Product Advisory

PROFIBUS Generation 2 Firmware Issue

<input checked="" type="checkbox"/> Product Advisory
Document ID	PA-15-12330
Edition	2015.09.14.0
Date	14-Sep-2015
Author	Eric GORY
Title	Industrial Communication, Product Marketing, France
Owned/Approved By	Syed ALI
Title	Industrial Communication Quality Manager
Approved By	Damien Leterrier
Title	Director, Industrial Communications

Affected Product:	PROFIBUS DR2-DPM-PCU (112011-5033) DR2-DPM-PCU-B25 (112011-5034) DR2-DPM-PCIE (112011-5035) DR2-DPM-CPU (112018-5005) ST2-DPM-PCU (112011-5031) ST2-DPM-PCIE (112011-5032)
Product Version affected :	PV: 1.0.0.0 (Firmware 1.0.17.0) and 1.0.1.0 (Firmware 1.0.20.0) only.
Product Version fixed :	PV: 1.0.2.0 (Firmware 1.0.21.0)
Product Description:	applicomIO PROFIBUS DP Network Interface Cards
Product Manager:	Eric Gory
Phone:	+33 (0)2 32 96 04 39
Issue Date:	September 14th, 2015
Subject:	Random values set to Outputs process data at card initialization

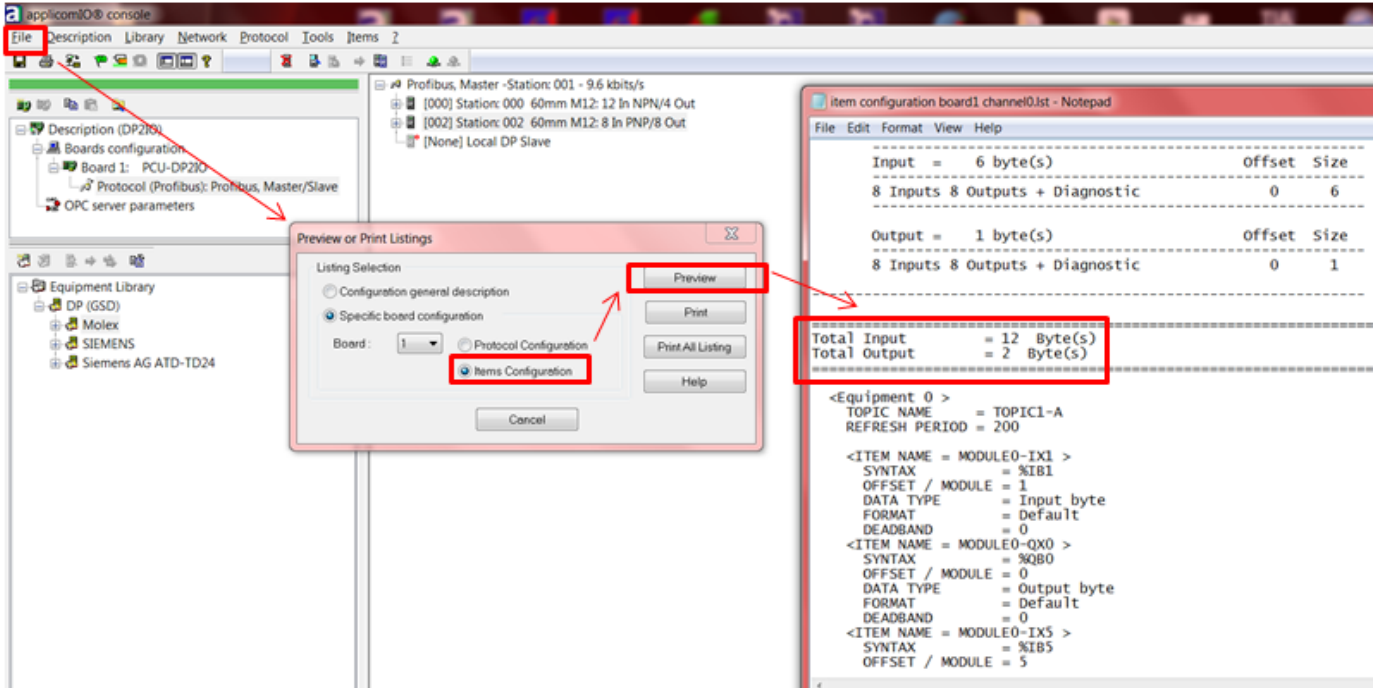
After the card's initialization (volatile or in flash configuration), random values are set to the outputs process data from byte offset 256.

As those values are sent to the slave device(s) once PROFIBUS data exchange starts, it may induce unexpected behavior and/or major damages.

Open the applicomIO Console, select *File > List and Print* and then select *Items Configuration* and then click on *Preview*. See picture below

If total output data size is lower than 256 bytes, you are not affected by the issue.

If total output data size is upper than 256 bytes, your must upgrade your card with **firmware 1.0.21.0 version**.
